CIRCUIT BREAKER HOUSING WITH JUMPERS

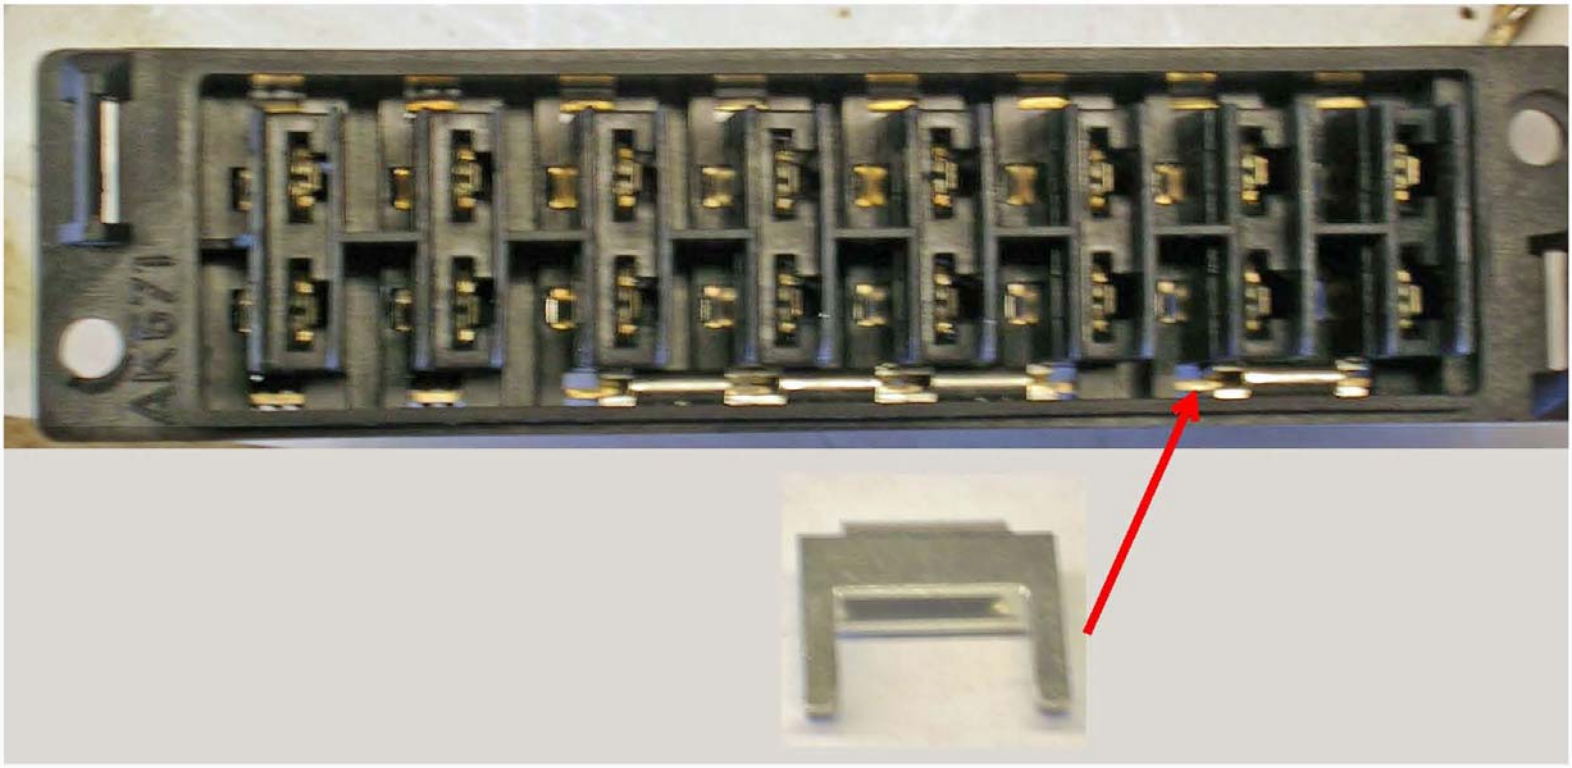
VIN # 44642 Problem, brake lights work intermittently found that the jumpers where not installed properly. When they where installed they did not saddle the connector shown by arrow, both side of jumper where on one side. All five jumpers where the same. This coach had this problem before with the jumper for the evaporator fans a few weeks ago.
